VERMONT YANKEE NUCLEAR POWER CORPORATION

AMENDMENT TO FACILITY OPERATING LICENSE

Amendment No. 62
License No. DPR-28

SAFETY EVALUATION BY THE OFFICE OF NUCLEAR REACTOR REGULATION

Figure 3.6.1
 Reactor Vessel Pressure
 Temperature Limitations
 for Operation Through 1.15E8MWH^(t)
 RT_{INDT} @ 1/4T = +90°F @ 3/4T = 75°F

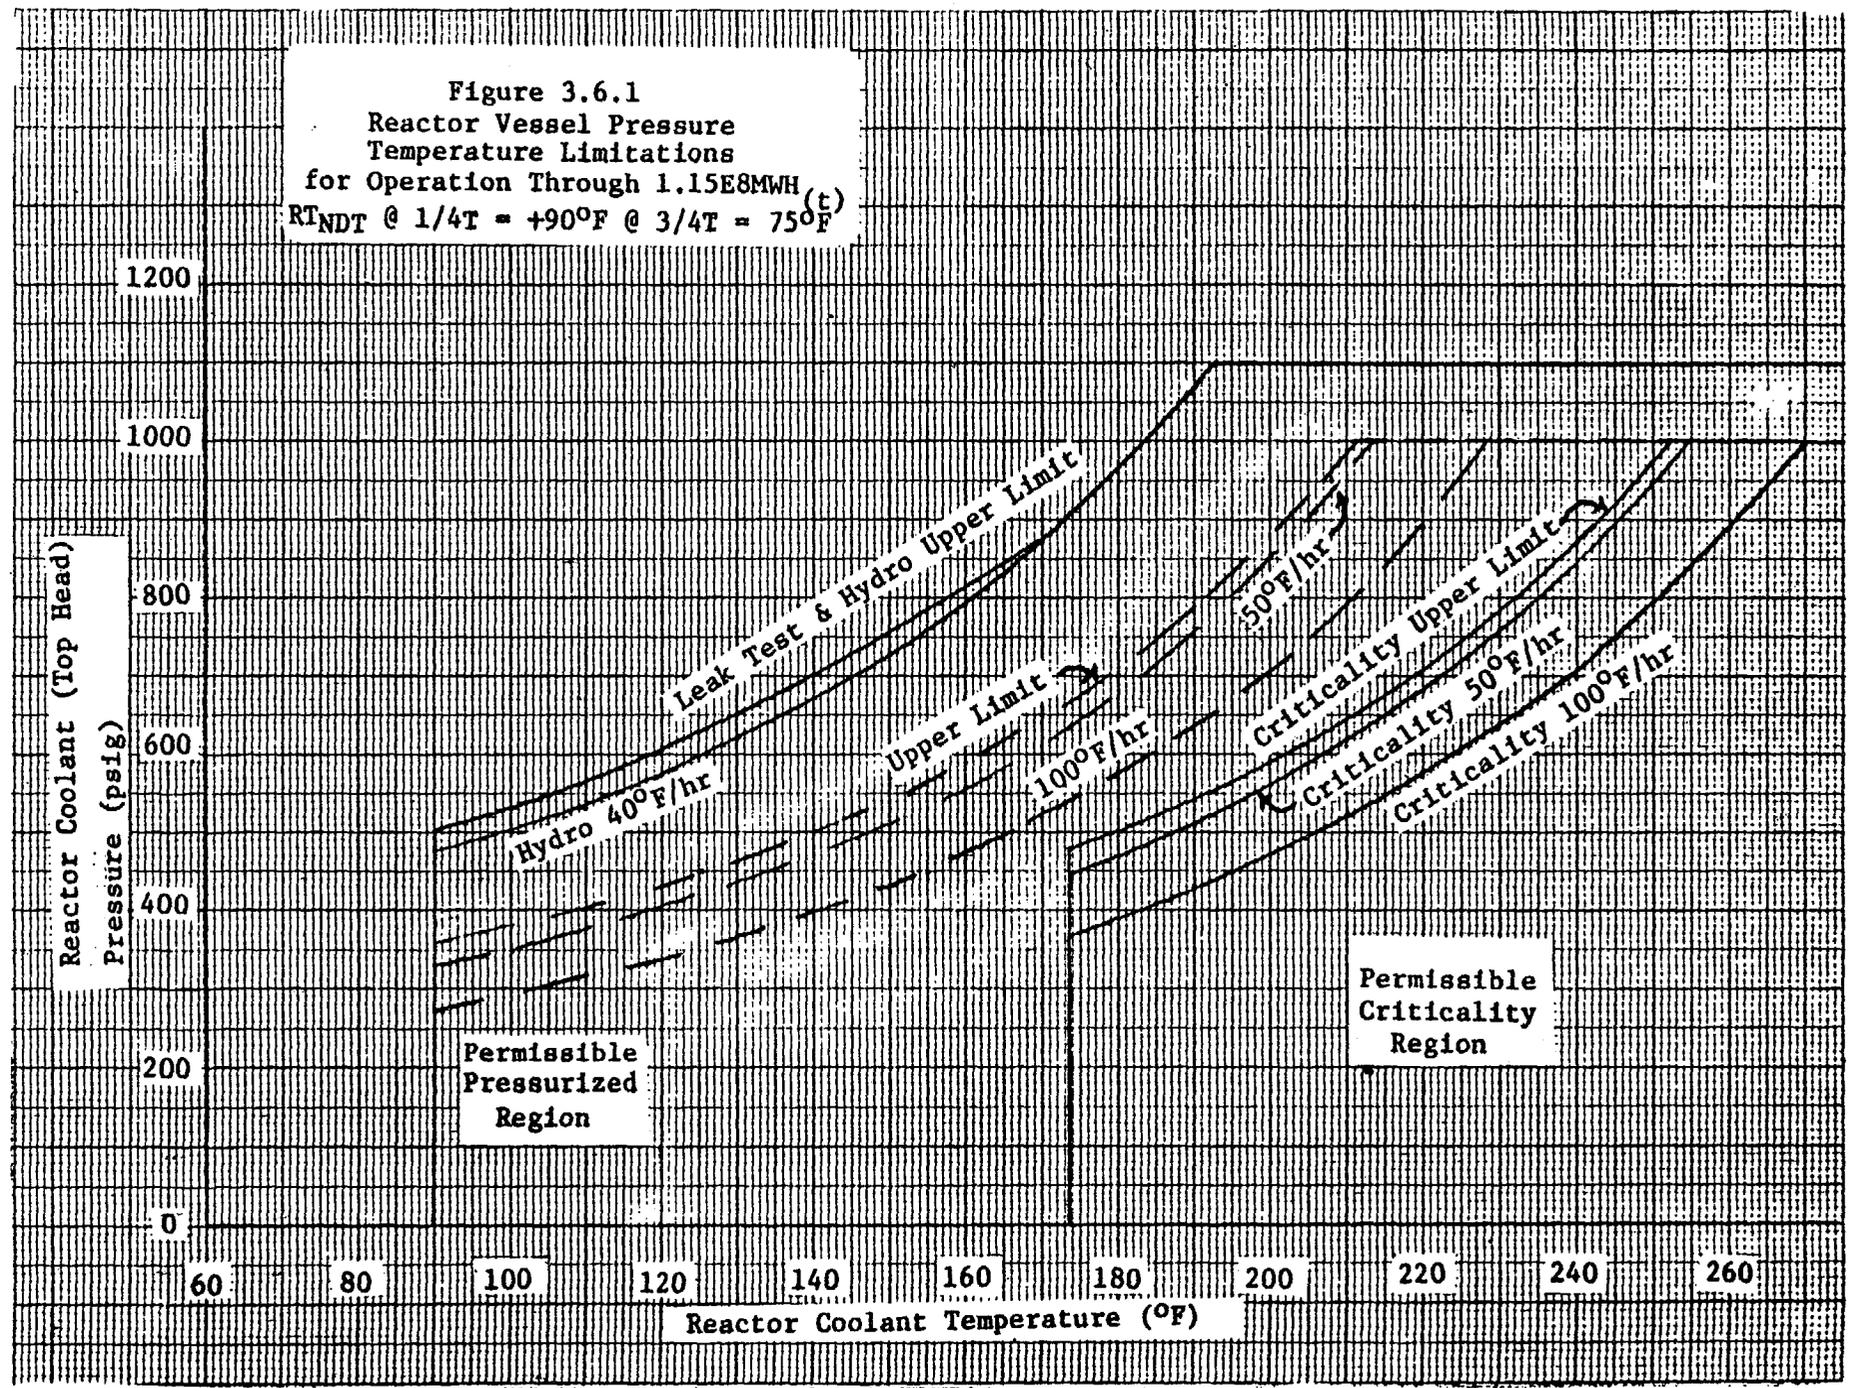
The pressure-temperature limit lines shown on Figure 3.6.1 for reactor criticality and for inservice leak and hydrostatic testing have been provided to assure compliance with the minimum temperature requirements of Appendix G to 10 CFR 50 for reactor criticality and for inservice leak and hydrostatic testing.

In letter dated September 5, 1980, the licensee proposed a revision to Figure 3.6.1 (Reactor Vessel Pressure Temperature Limitations for Operation through 8.0E7 MWH (t)) of the Vermont Yankee Technical Specifications. The proposed operating limits were calculated in accordance with Appendix G, 10 CFR 50 and Standard Review Plan 5.3.2 which includes Branch Technical Position MTEB 5-2. These new operating limits were based on a fluence at the vessels inner wall of 3.83×10^{17} n/cm², calculated for operation through 1.15 E8 MWH (t) (which is estimated to occur late in 1983). At this point in time, the limiting material in the beltline with an original RTNDT of 60°F was calculated by the licensee to have an RTNDT shift of 30°F based upon recent dosimetry data (showing an increase at Vermont Yankee of 4.3 times that reported in the FSAR). We have reviewed with the licensee the analysis by which an inner vessel wall fluence was calculated to produce the 30°F RTNDT shift for the limiting material. In order to complete our records for reference in reviewing future RTNDT shift calculations for Vermont Yankee, the licensee has agreed to forward the details of the most recent analysis to the USNRC including determination of limiting material, redetermined fluence, and RTNDT shift calculations.

We have reviewed the proposed changes to the pressure-temperature operating limits and conclude that they are in accordance with Appendix G, 10 CFR 50 and Standard Review Plan 5.3.2. The use of Appendix G for establishing safe operating limitations will ensure adequate safety margins during operation, testing, maintenance and postulated accident conditions and constitute an acceptable basis for satisfying the requirements of NRC General Design Criterion 31, Appendix G, 10 CFR 50.
